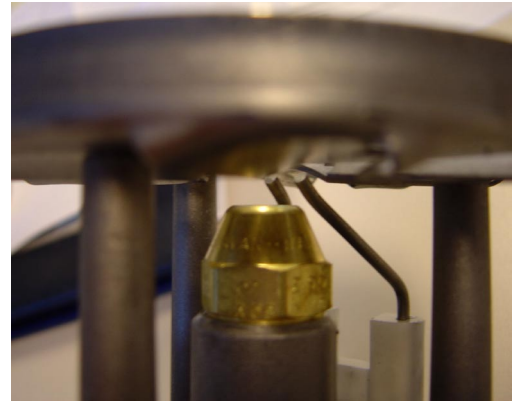
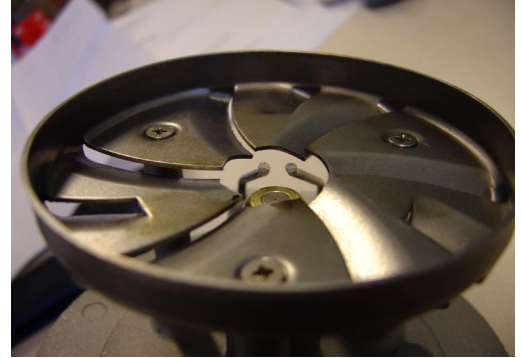
1. Substitute DIESEL NOZZLE 3400 0363 (0,85GPH - 45;W) with **3400 0331 (0,75GPH - 60;A CT)**
2. Substitute ELECTRODE 0805 0021 (SCOUT) with **0805 0017 (KE-KC-KD style)**
IMPORTANT: Adjust the position of the electrode s points as per attached pictures, in order to have them just in between nozzle and air-turbulence ring.

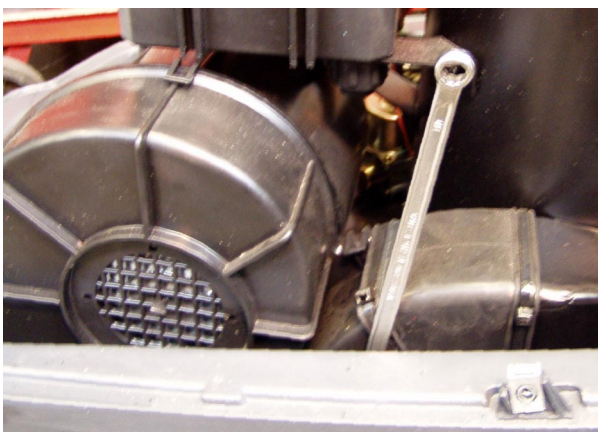
3. Adjusted Air Flap setting: almost closed (see pictures)
